WILDGRASS FILING NO. 1

PUD DEVELOPMENT PLAN
EL PASO COUNTY, CO

AMENDMENT 2017
Revised Lots 15-40

AMENDED PUD DEVELOPMENT PLAN

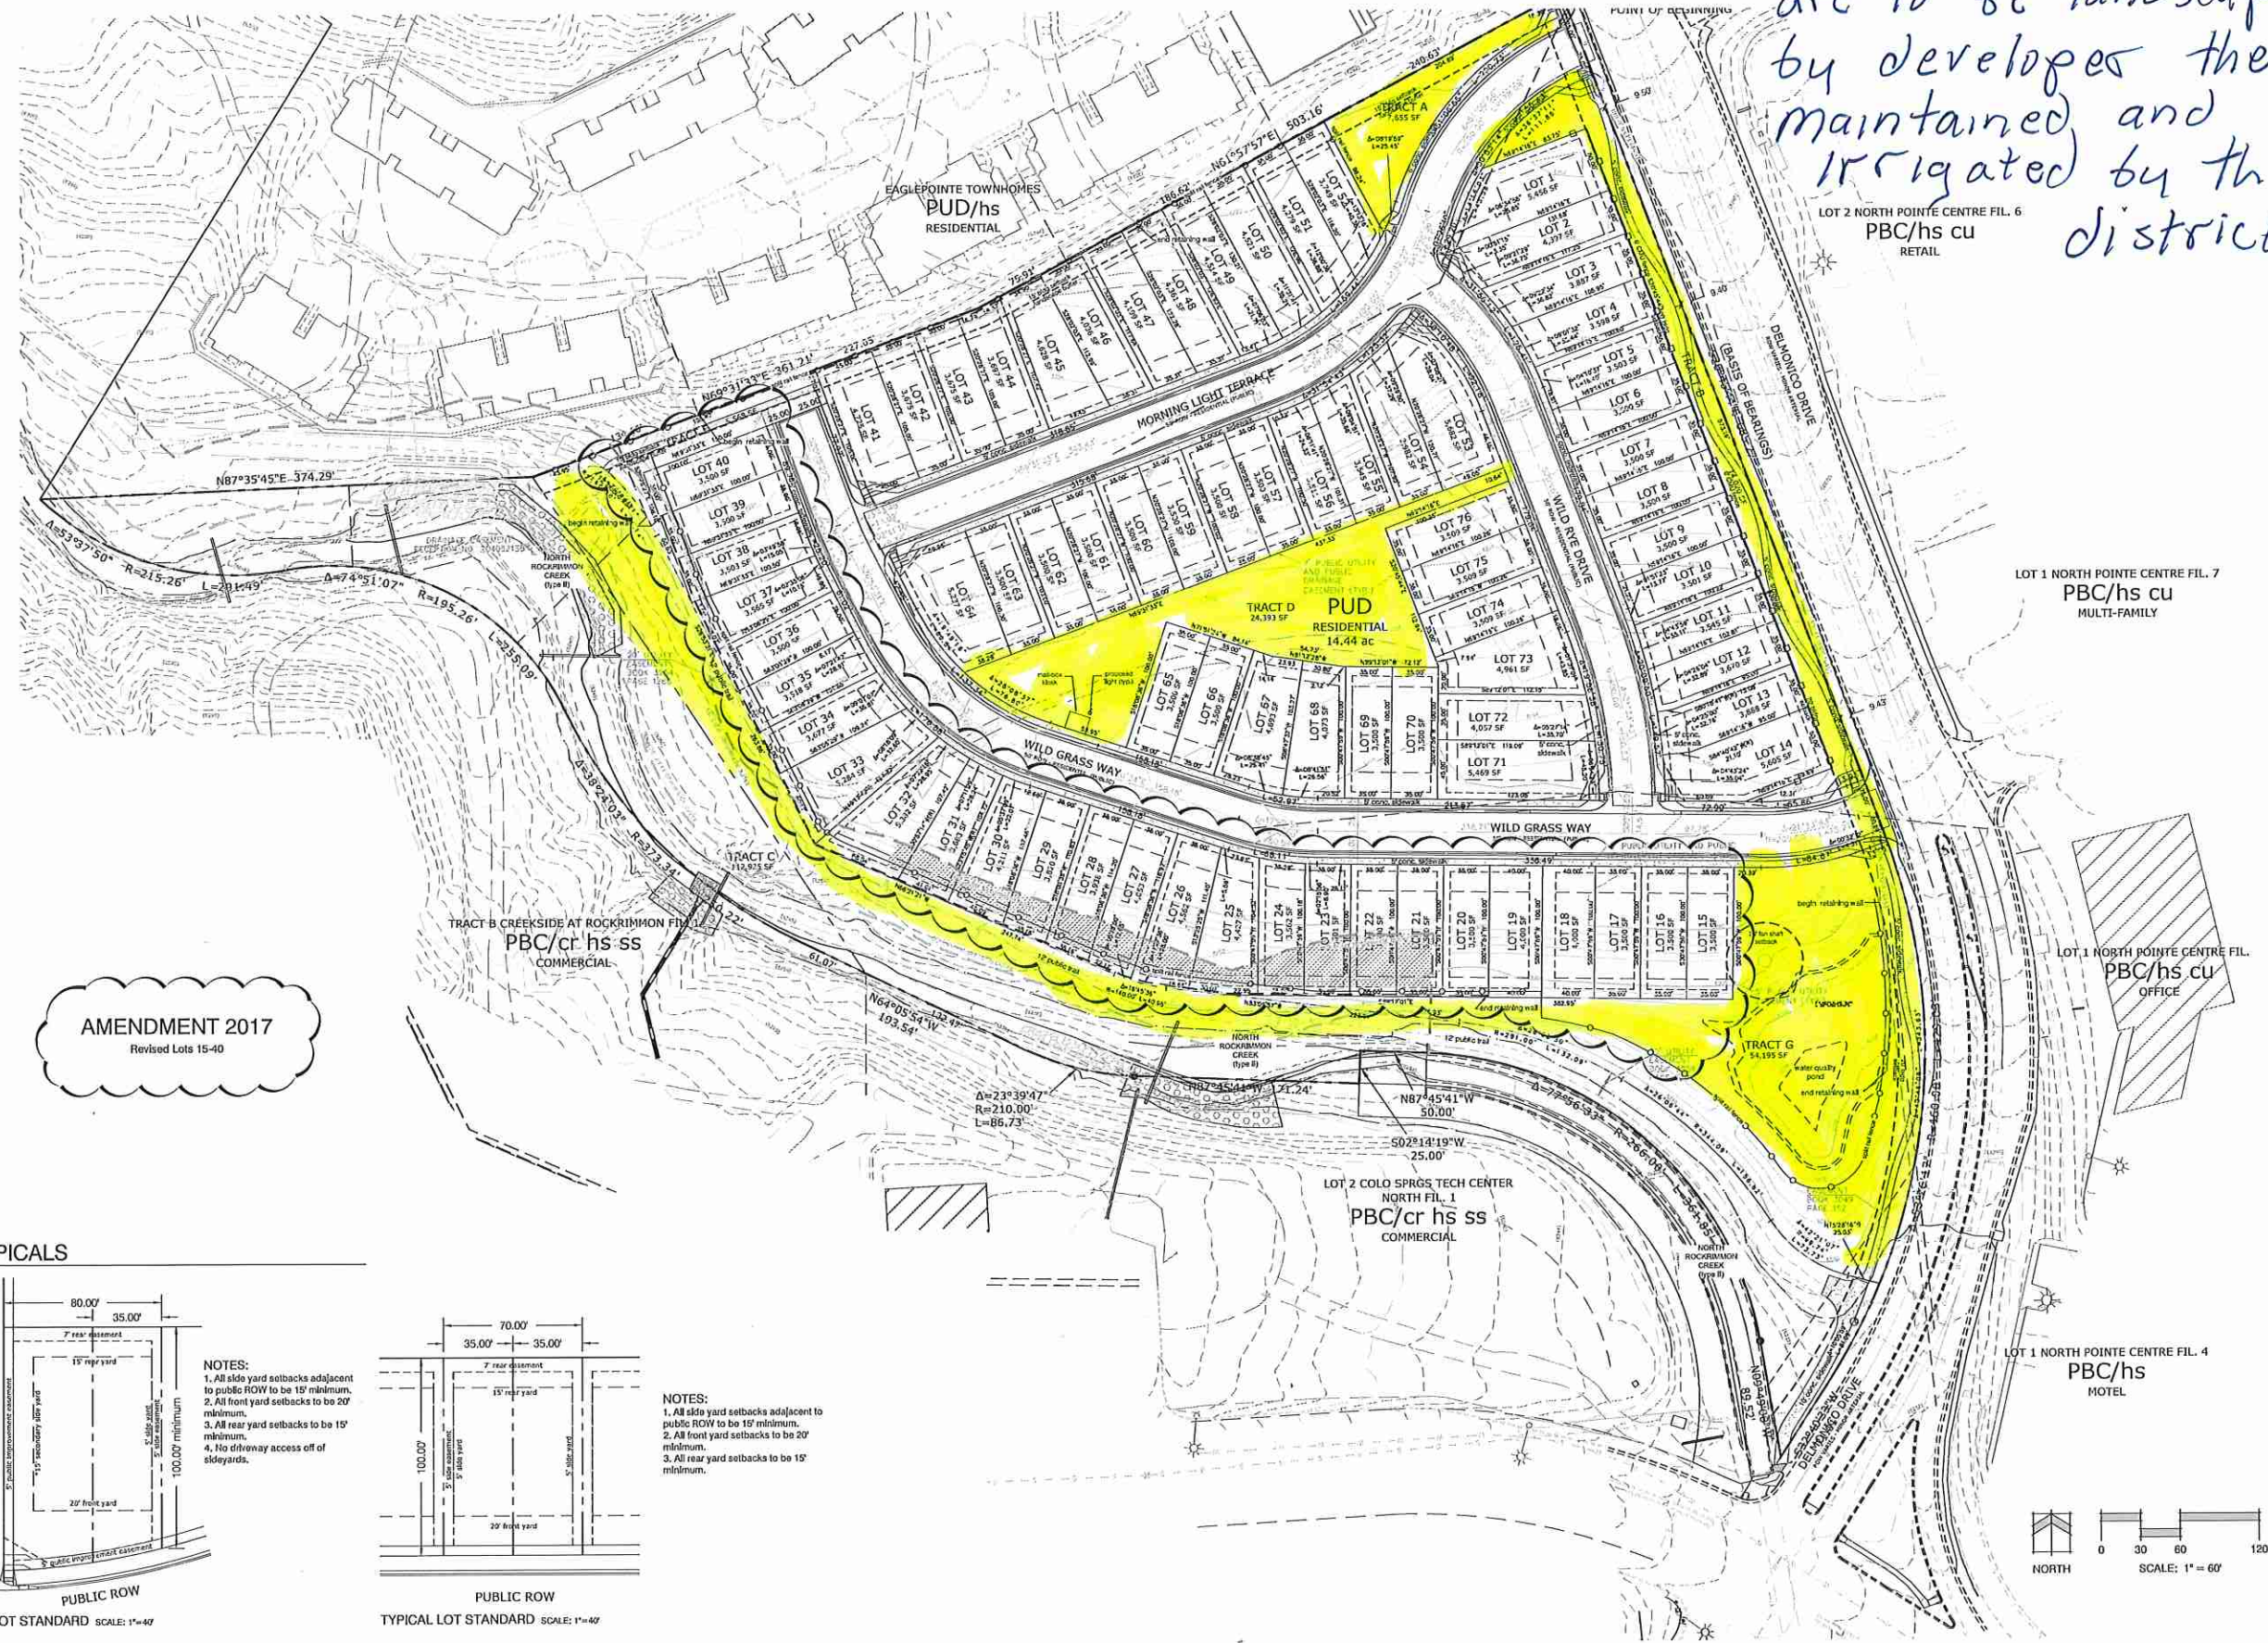
All highlighted areas are to be landscaped by developer then maintained and irrigated by the district

LANDSCAPE PLAN

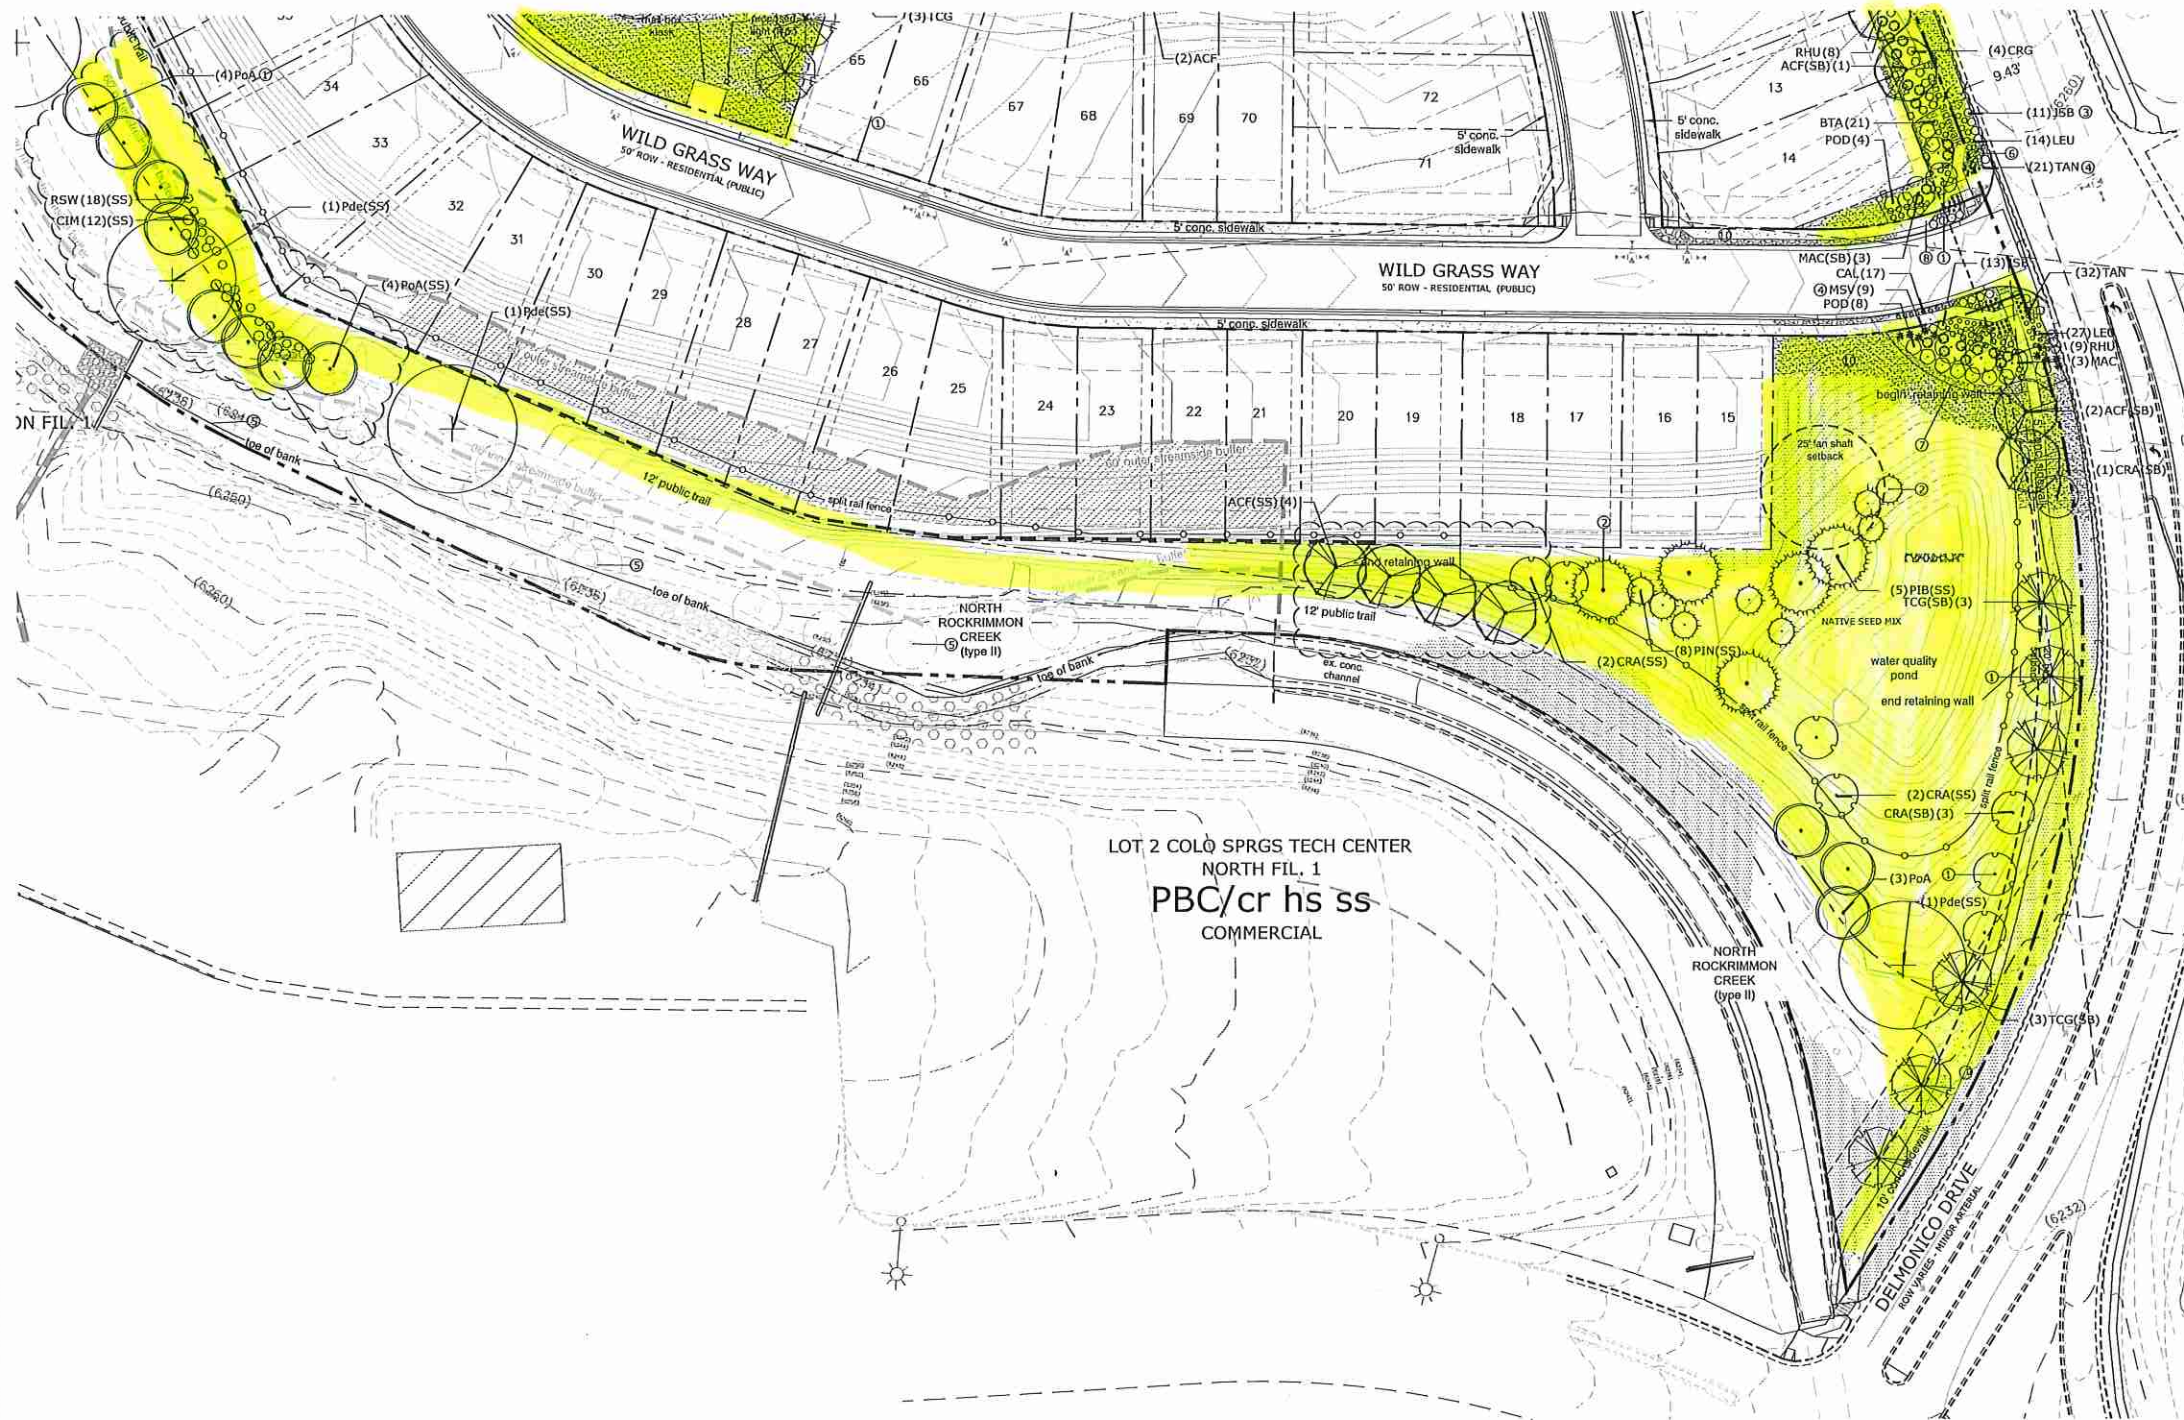
Detention pond to be maintained by the district - it is landscaped as well
